## ADDENDUM NO. 2

### COWLITZ COUNTY HEADQUARTERS LANDFILL 2025 GAS COLLECTION AND CONTROL SYSTEM EXPANSION PROJECT

Project No. 8467

For the Department of Public Works, Cowlitz County, Washington

**M2.04**

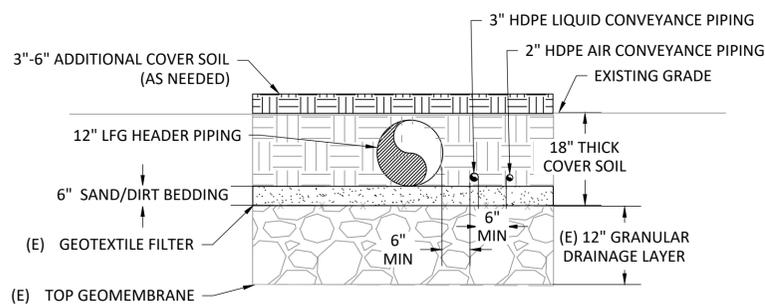
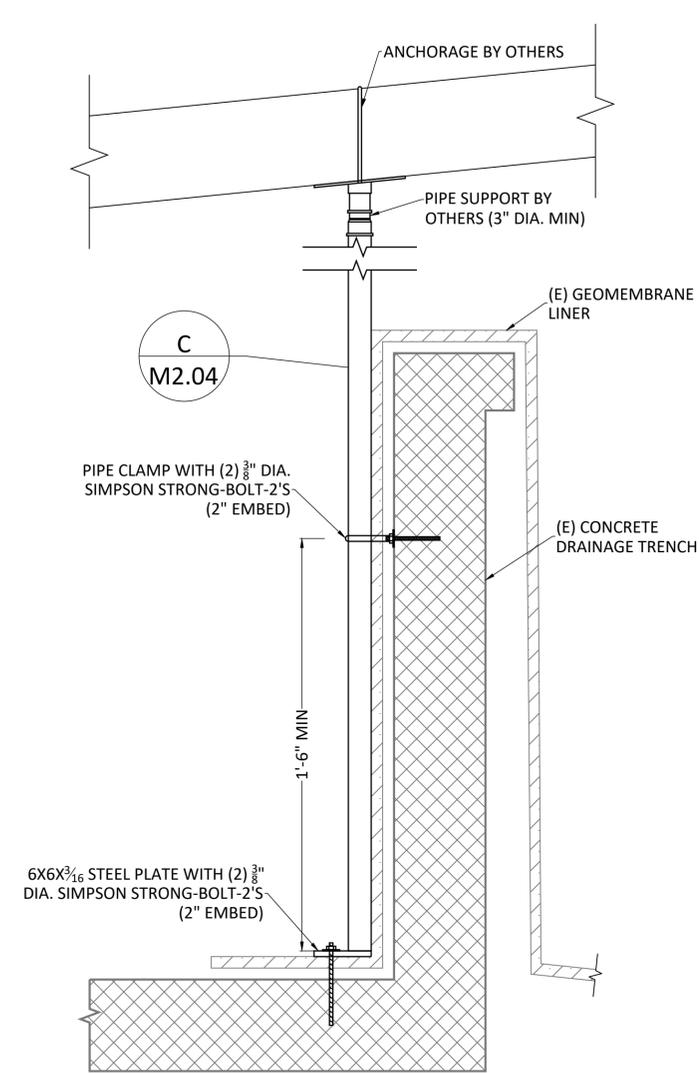
10. **In the design, it shows sand bedding in trenching for Cell 1, and it does not show anything for the other cells. Please confirm - Detail D and F on sheet M2.04**

*Sand Bedding occurs in trenching of the closed section of cell 1 to prevent direct contact of header and lateral piping with the top liner system.*

**D** LIQUID CONVEYANCE ISOLATION VALVE VAULT DETAIL

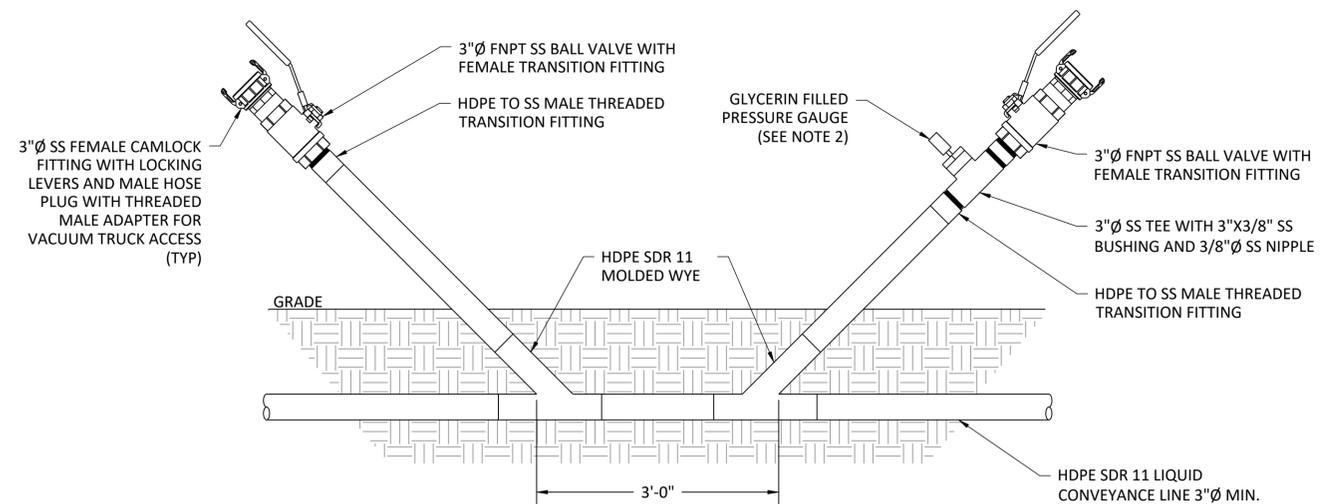
13. **For below-grade valves, are vaults required? This does not show up in the design. If yes, can you confirm the quantity and specifications on the vaults?**

*The only vaulted valve is on the 3" liquid conveyance line near the tie-in to the 8" LCS cleanout. See detail D/M2.05. All other below grade valves will have valve extension handles.*

**M2.07**

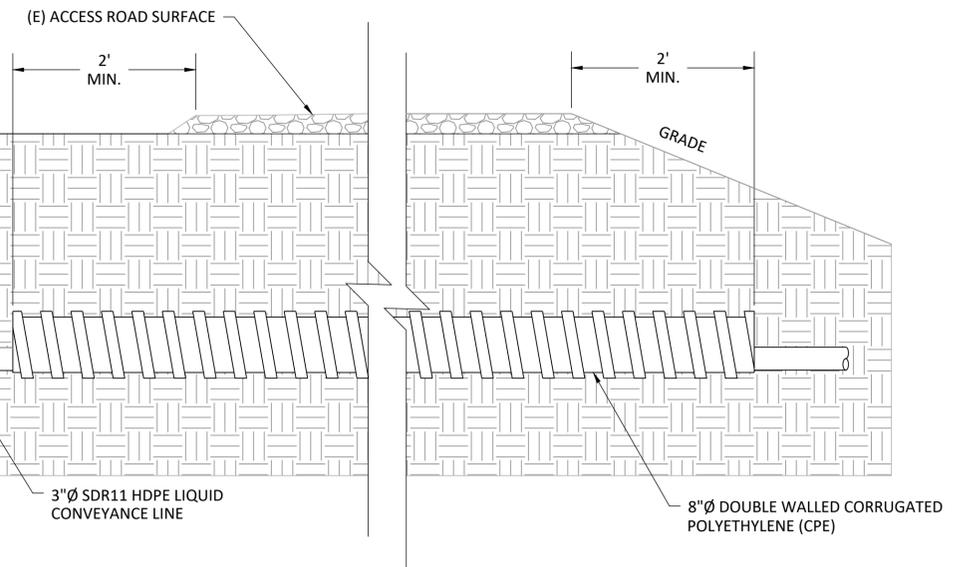
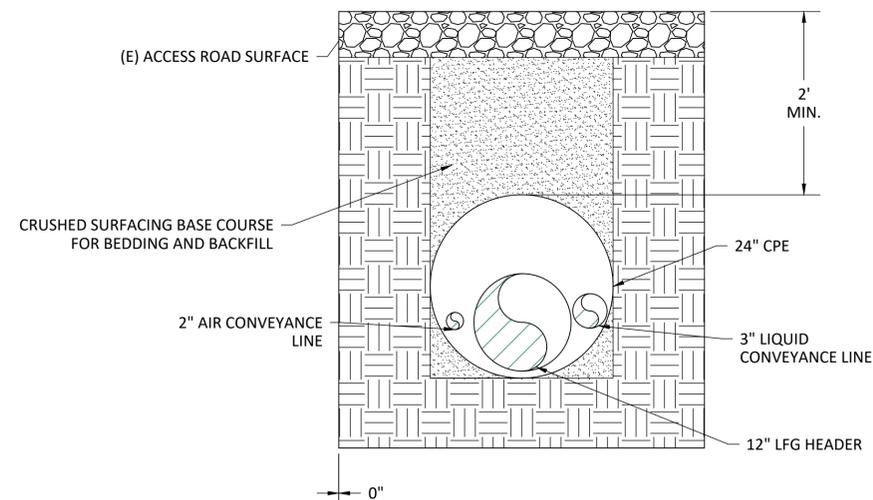
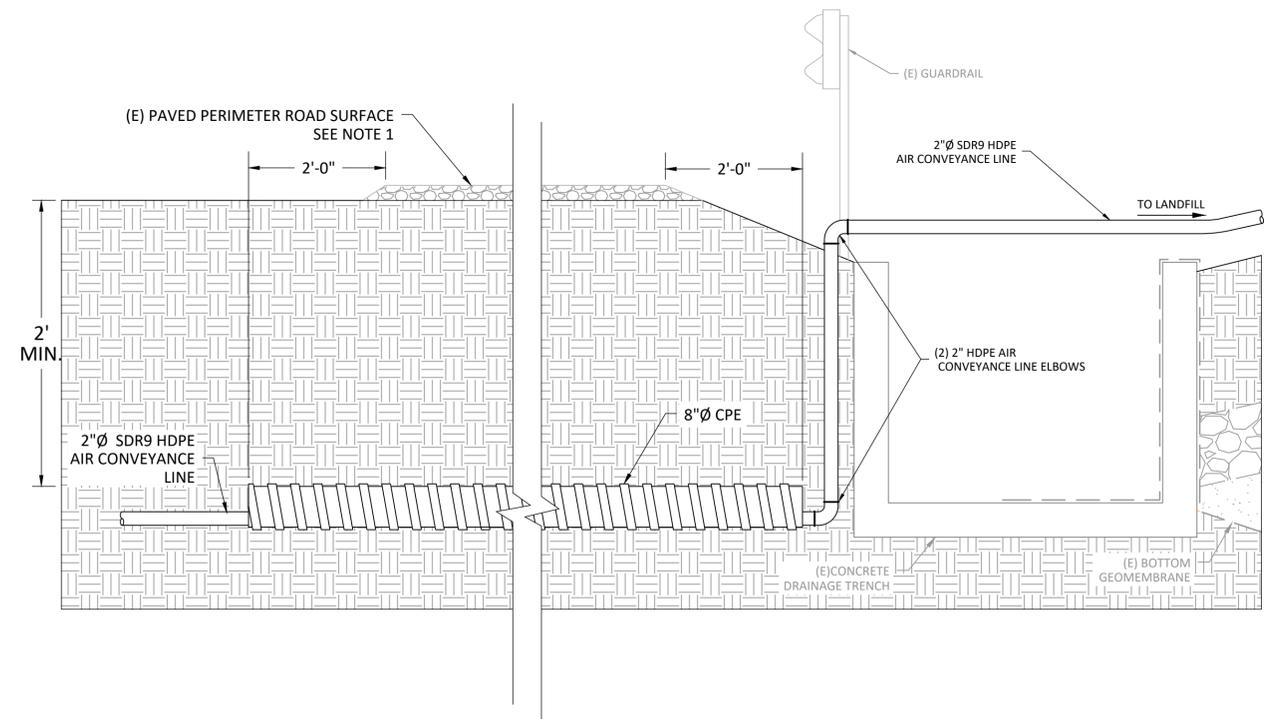
9. **Do all road crossings shown in the design require rocks on top for the finish layer, as shown on Sheet M2.07?**

*Bedding and backfill for all road crossings shall be crushed surfacing base course per WSDOT Standard Specifications Section 9-03.9(3). Asphalt for the road crossing for the 2" air line shall be patched per Cowlitz County Standard Plan CC-1303 (available download at <https://www.co.cowlitz.wa.us/DocumentCenter/View/634/CC-1303-Pavement-Patching?bidId=> ).*
